More on the proposed desecration of Glen Etive

Notifications that two of the Glen Etive hydro applications had been withdrawn were issued by Highland Council last week but, before anyone celebrates, they have been replaced with new applications for the Allt Mheuran and the Allt Fhaolain. That re-starts the whole planning process. If you objected first time round, that objection is no longer valid. If you did not manage to comment then, now is your opportunity!

Highland Council has allowed Dickins Hydro Resources to resubmit most of the original planning documents with the new applications. The main changes for each application are explained in a Supplement to the Environmental Impact Assessment (EIA) for each scheme.

Fig. 2 Temporary access track to intakes during construction to be reinstated to allow ATV access afterwards on Bhiorain, Gaoirean, Charnan, Fhaolain and Ceitlein.

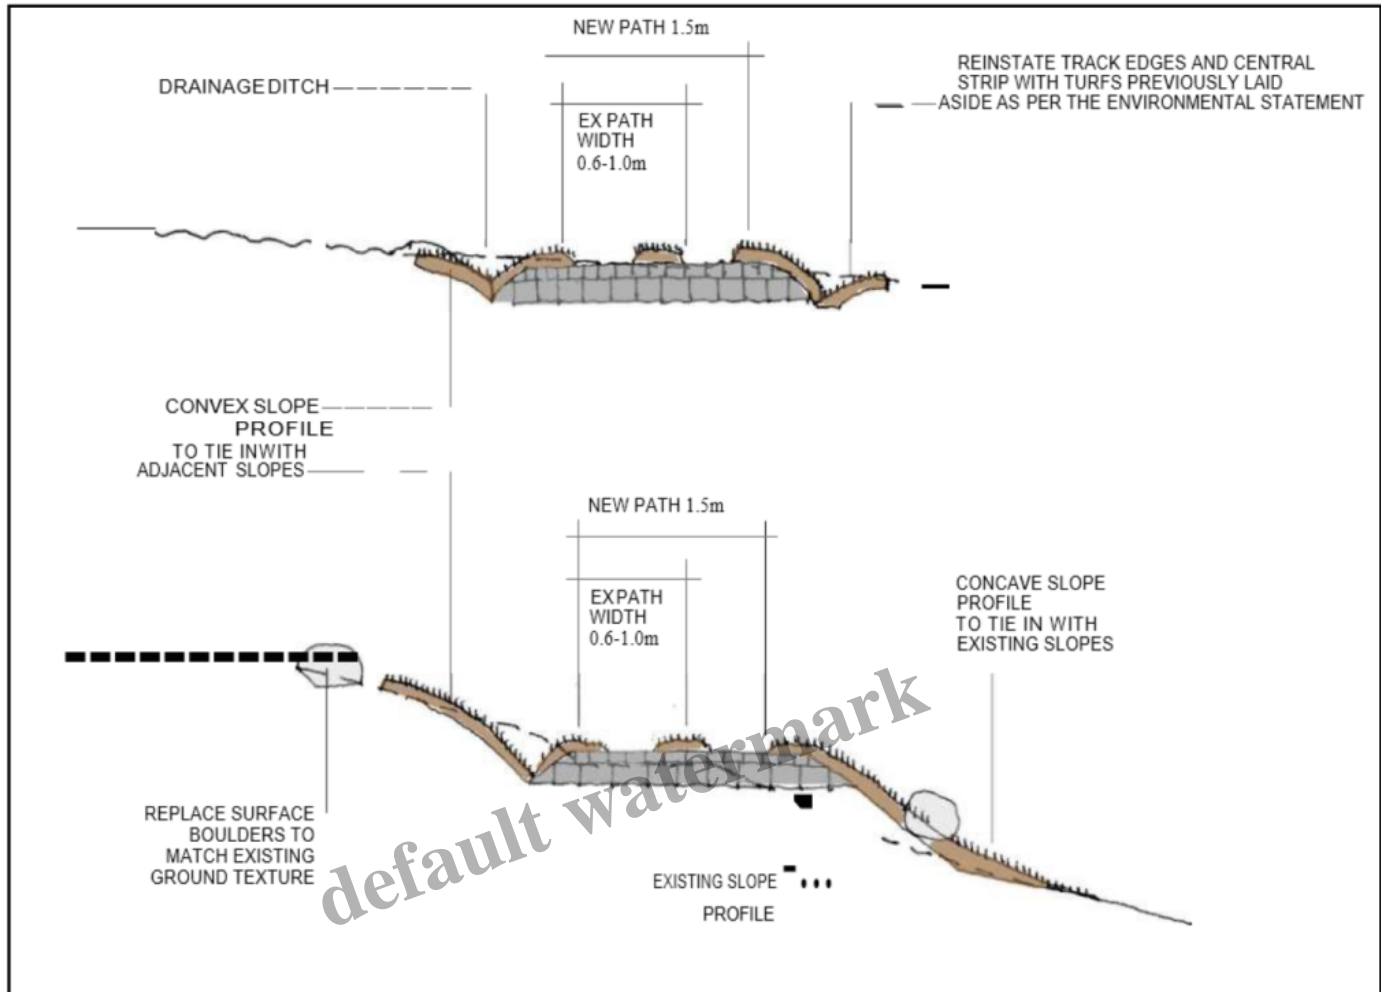
The text below the diagram appears to clarify that the proposal to narrow construction tracks to ATV width applies to five out of the seven schemes. While the Allt Mheuran tracks are now to be removed completely (see below) its not clear what is being proposed for the Allt Chaorunn where some new track was to be removed and some retained.

The diagram illustrates that Dickins Hydro is not actually proposing to restore the tracks – which would mean removing the imported material – but rather to cover them up. That will have a lasting impact on landscape and ecology. What is not explained.

Looking down Alt Mheuran, Beinn Trilleachan beyond, with approx position of former proposed permanent hydro track marked in red. Photo and photomontage copyright Tim Parkin (<http://www.timparkin.net>)

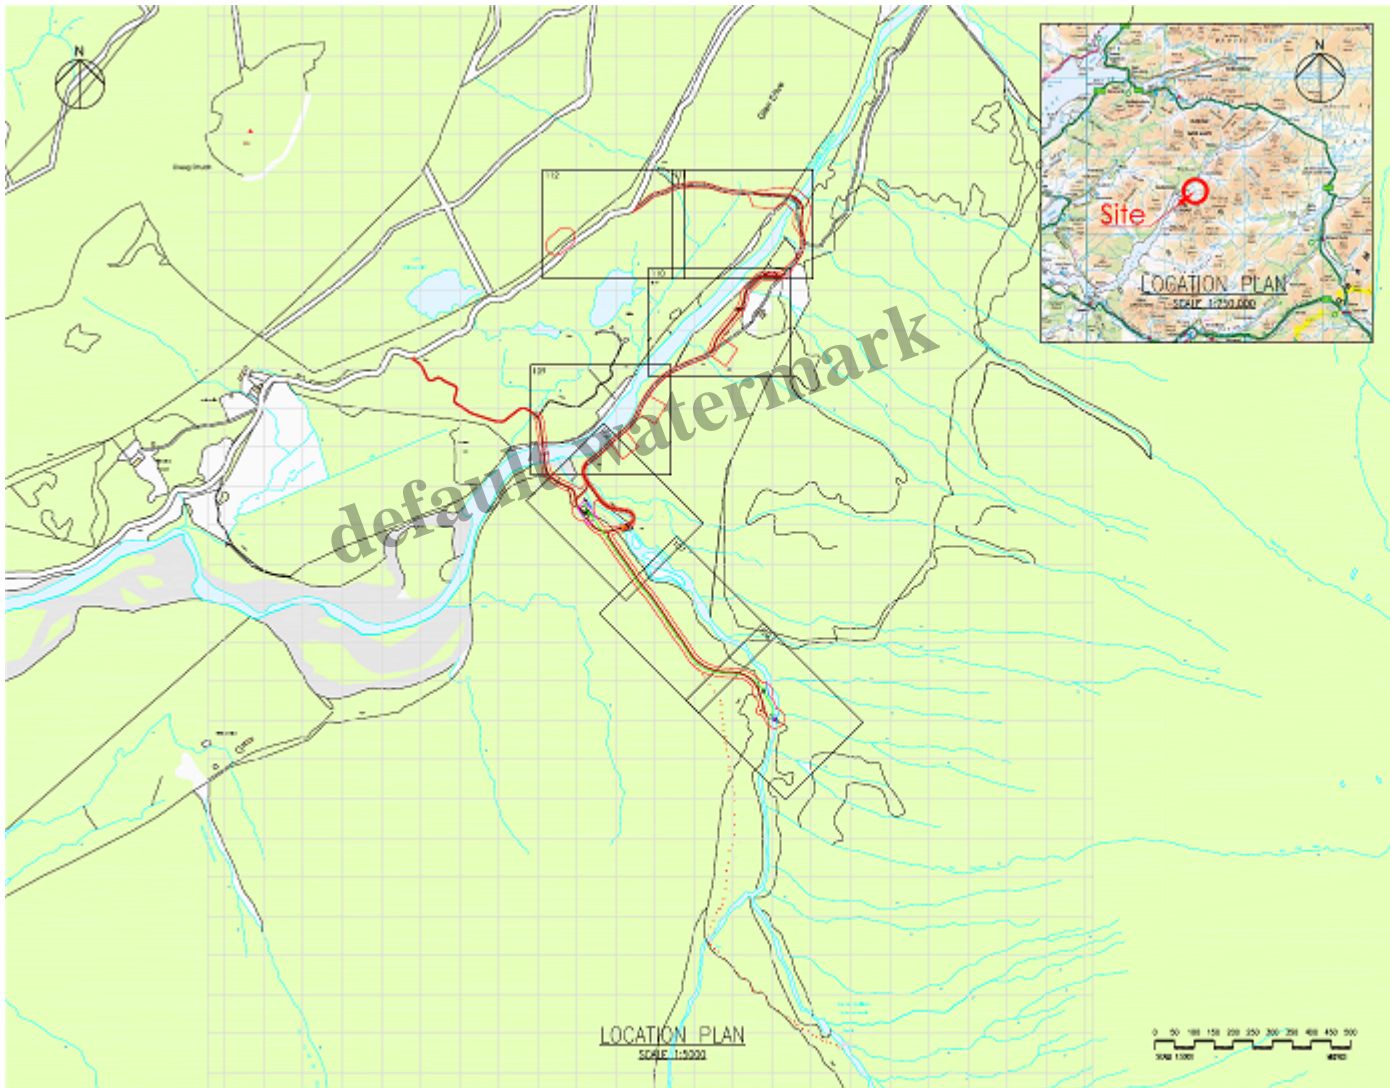
This sounds welcome in principle and will reduce the landscape impact significantly (photo above). It rather begs the question though if its feasible to lower the intakes and remove the tracks at the Allt Mheuran, why not apply the same thinking to the other Etive schemes too?

Revised location plan. It appears only the track above the powerhouse will be removed, leaving a new and “upgraded” tracks along the bottom of the glen.

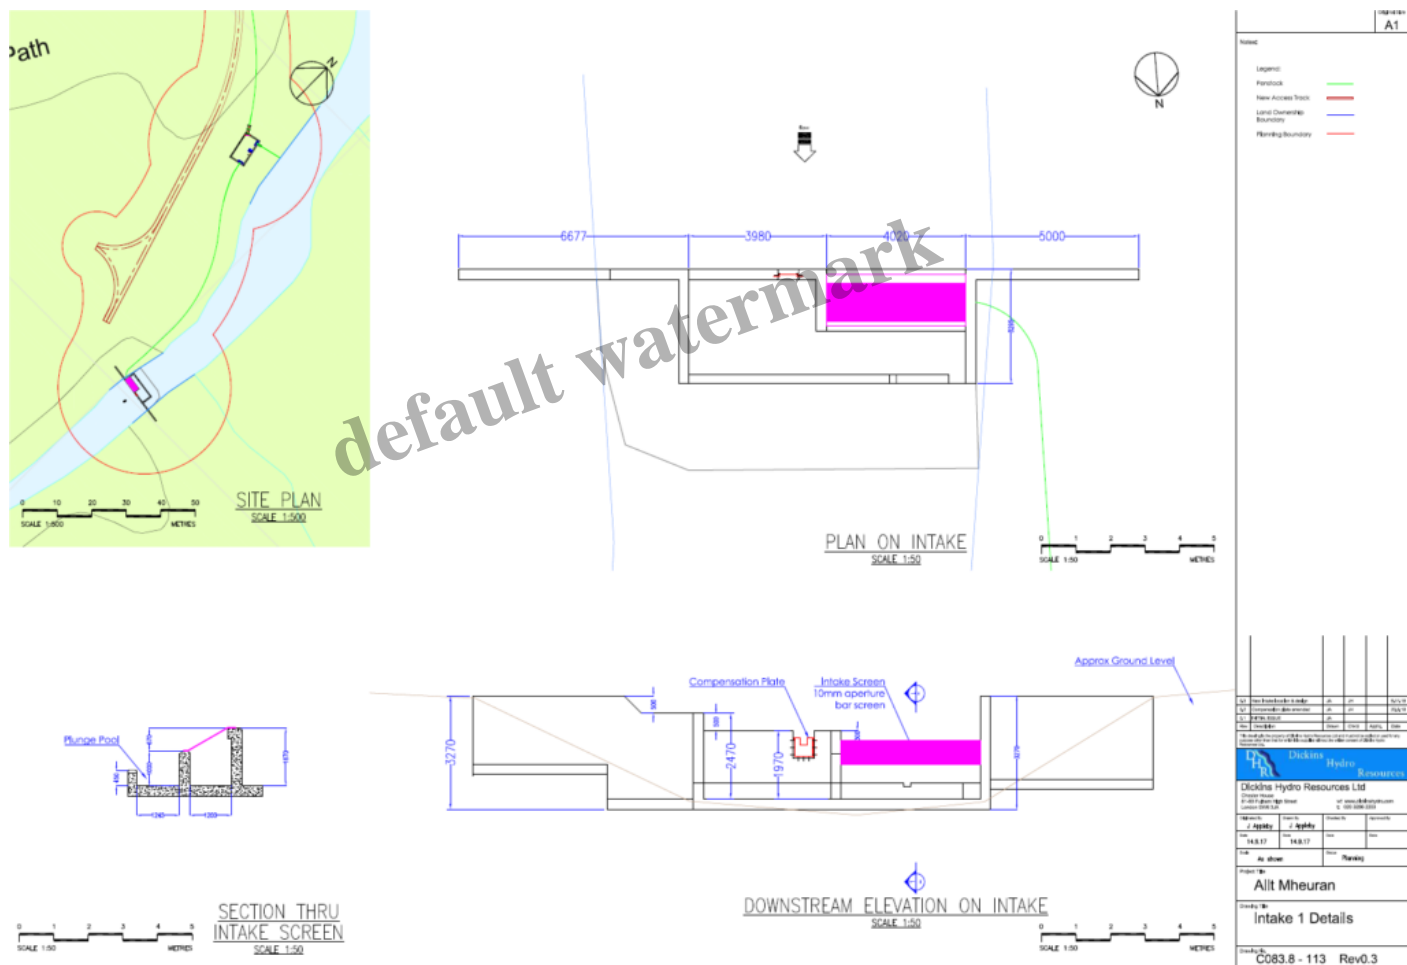
A new permanent access track to the Mheuran powerhouse, around the south side of Coileitir, is proposed. SEPA request a habitat survey for the new access track, however DHR Ltd submitted this report and habitat map with the original planning application. So not all new construction tracks are going to be restored after all? What is the specification for this new track? The Developer says this will be upgraded and realigned but gives no apparent consideration to the landscape impact.

- There is second section of new, and presumably permanent, access track which heads more directly across the River Etive (see plan above). Again, I cannot find any assessment of the landscape impact.
- The Zone of Theoretical Visibility Assessment has not been revised – it dates from December 2017 – despite the significant changes to the scheme

The Intake 1 details are still dated 2017.

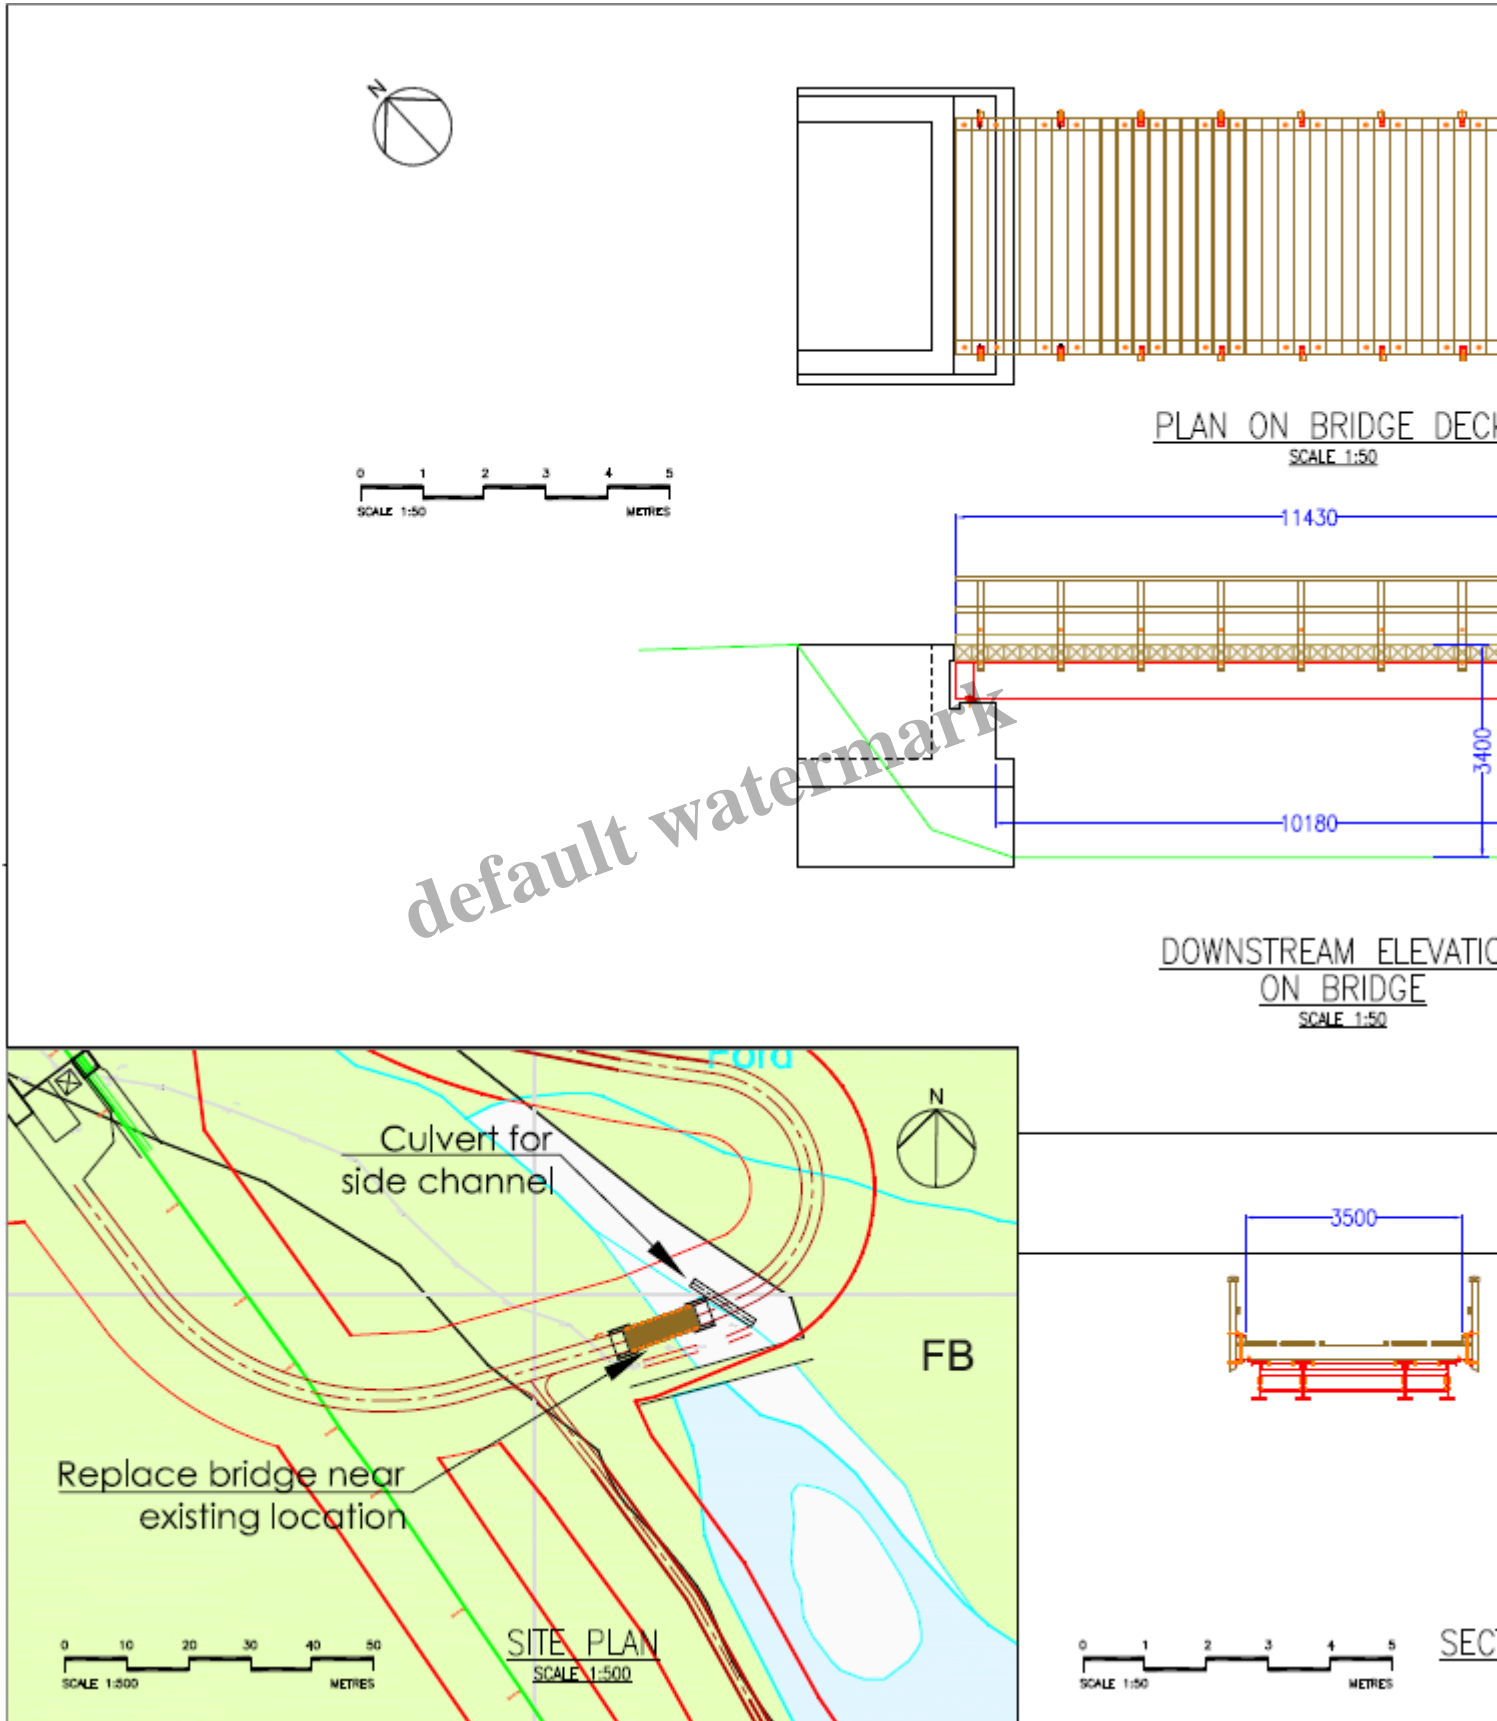
- While a new map has been added to the intake document dating from last year showing its location (along with what appears to be a permanent access track!) its unclear how the proposed design will fit in the proposed location, let alone how it will look. The size of any pool, the use of rip rap bouldering and whether the concrete walls will be faced in stone appear not to be considered.

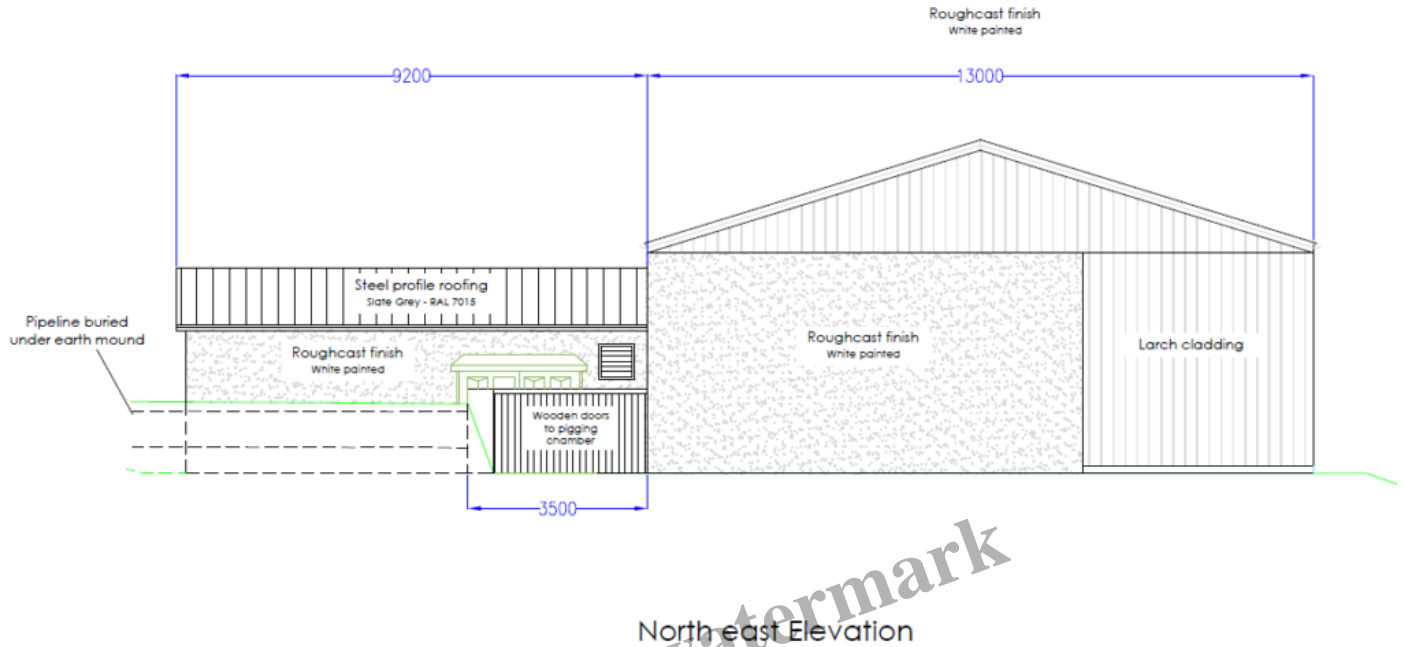
- Design details for the new bridge are also not supplied. The supporting pillars appear to be in concrete, totally out of keeping for Glen Etive

The previous Zones of Theoretical Visibility dating from Dec 2017 has been resubmitted – perhaps this is just a mistake?

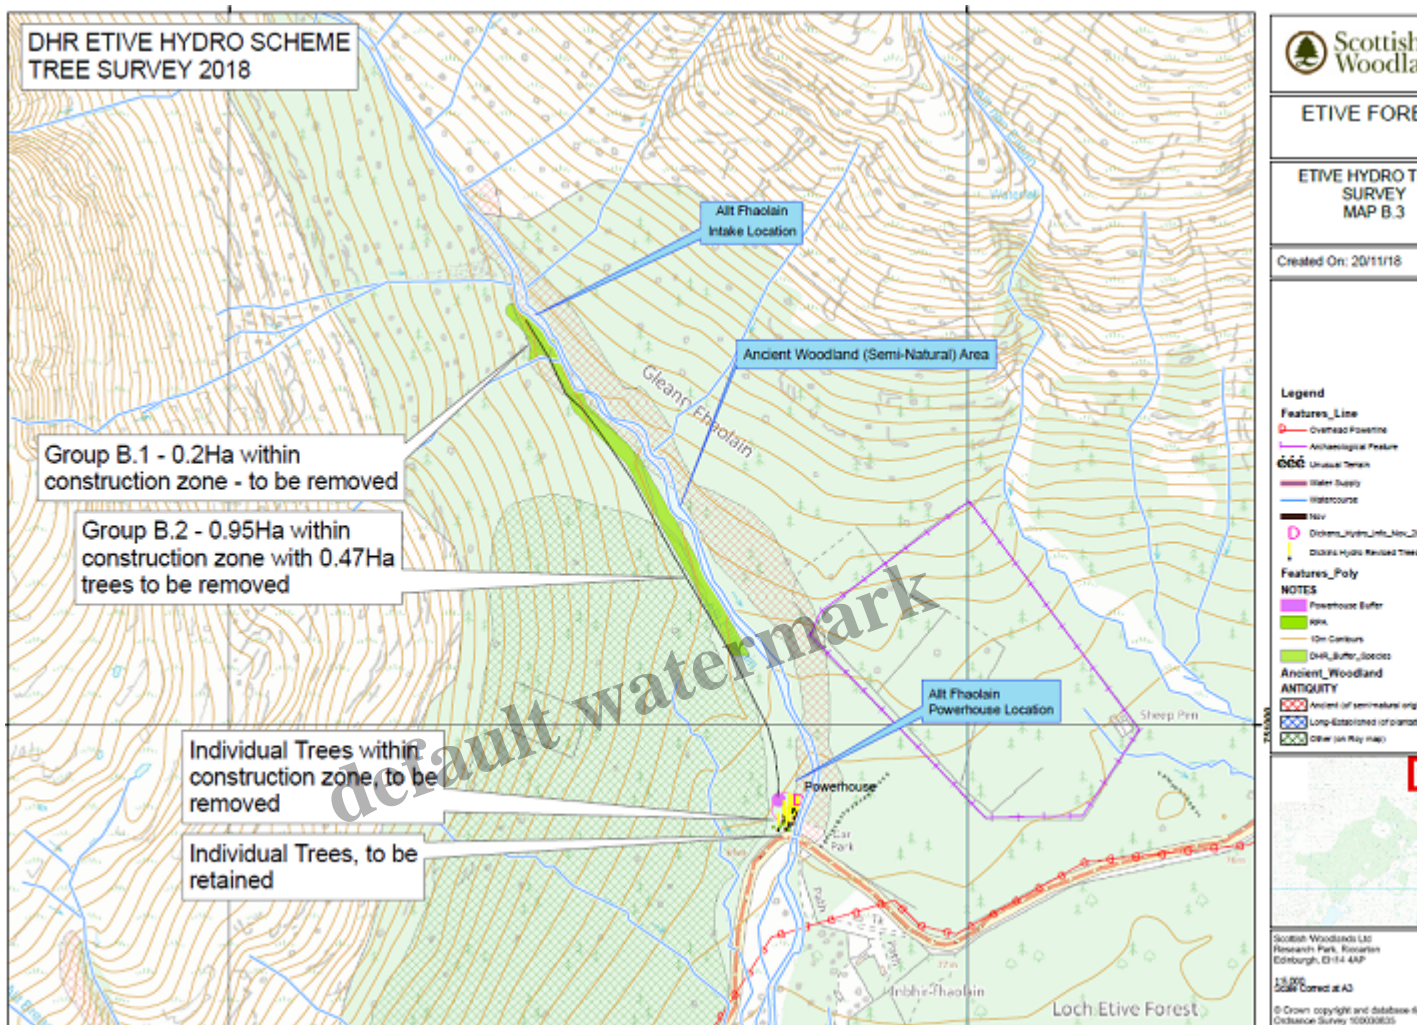
While the supporting documentation claims the Landscape Impact Assessment has been revised, the Assessment of Zones of Theoretical Visibility (Doc 5.6) still dates from December 2017 and still shows the powerhouse south of the road. While the powerhouse should now be less visible the assessment failed to include any consideration of the impact of the “upgraded” and new sections of access track on the landscape.

impact of tracks for the other Etive schemes the Developer appears to have felt under no obligation to provide this for the revised Allt Fhaolain scheme. That is NOT good enough and reason enough to object to this application.

Ancient woodland is marked with brown hatching

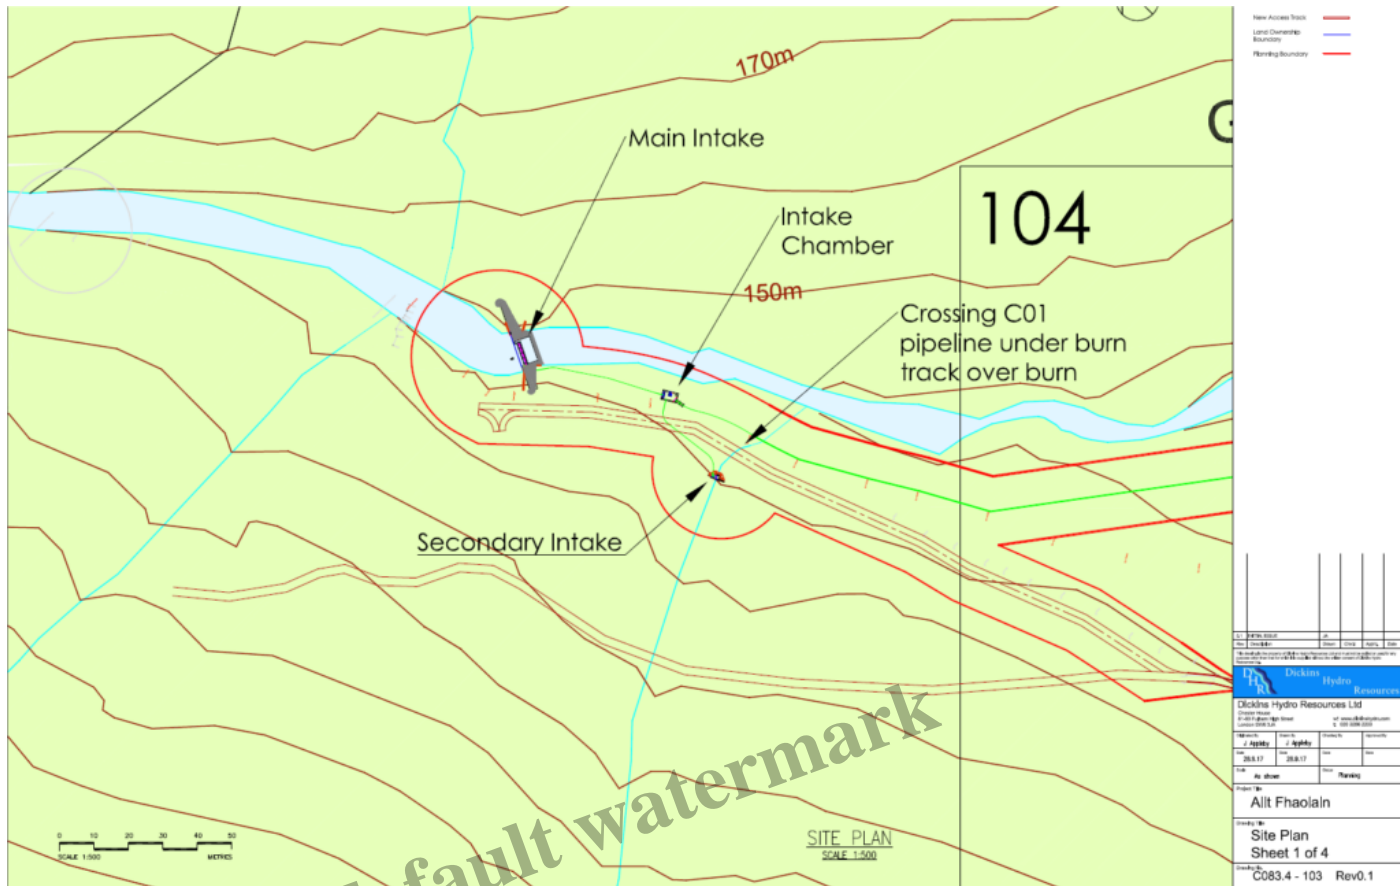
Ancient woodland runs along the Allt Fhaolain and the scheme will destroy some of this in its upper reaches, like the other schemes on the west side of the River Etive. There is still no proper assessment of the impact of these schemes on native woodland or on the scenery as the forest plantations are felled.
